Attachment 1- Answers and Clarification Document

Bidders' Questions.

(AG)

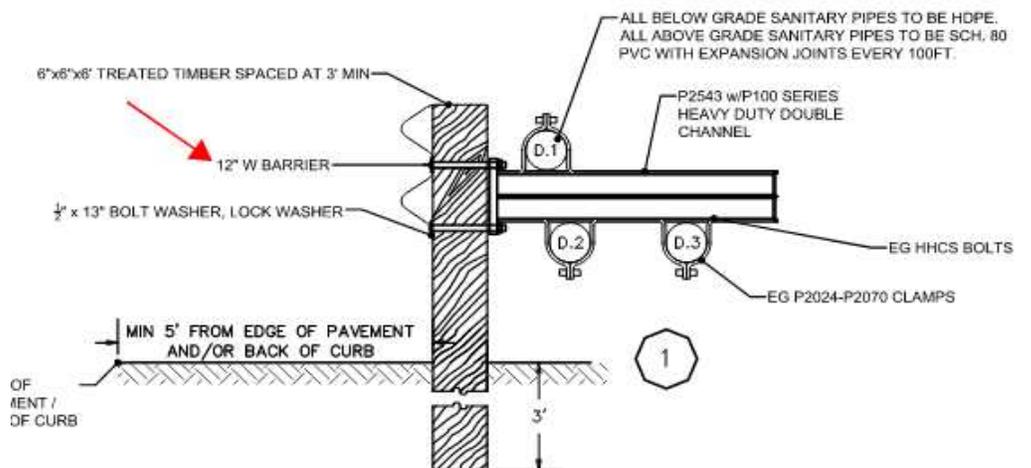
1. Can we get some clarification as to what a **12" W Barrier** is? See below.
 - a. The 12" W Barrier is a 12" wide metal beam that whose purpose is to serve as crash barrier and a visual cue to the driver. Specification of the Guard rail 12" W Barrier is reflected on sheet C-1402- AG Notes -Section 2 (b)
2. What are the 2 humps on the left side of the timber post at the top of the post?
 - a. The 2 humps on the left side of the timber post are the peaks of the 12" W Barrier that will stick out. See below image taken from google.
